REMARKS/ARGUMENTS

This Preliminary Amendment is filed concurrently with a Request for Continued Examination (RCE) in response to the final Office Action of May 5, 2008.

FIG. 4

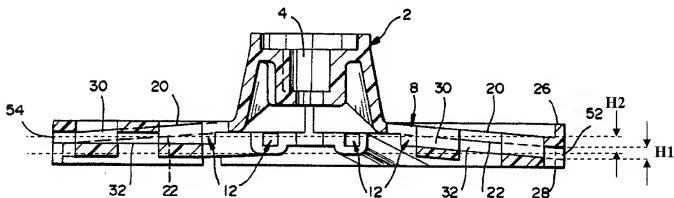
Similar to Jones '465, Jones '278 is silent regarding the spacing of the planes of the openings **52**, **54**. Referring to FIG. 4 of Jones '278, reproduced below with adjacent planes and distances corresponding to H1 and H2 superimposed, the distance between the planes of the openings **52**, **54** are, at best, about equal to the height of a cutting filament **10**. Thus, Jones '278 does not teach or suggest adjacent planes that are spaced from each other by a distance that is greater than or equal to approximately 1.8 times the height of each string.

The Examiner asserts that "the distance between the planes could be 1.8 times or greater than the thickness of a string which has a lesser height or greater height"; however, the Examiner
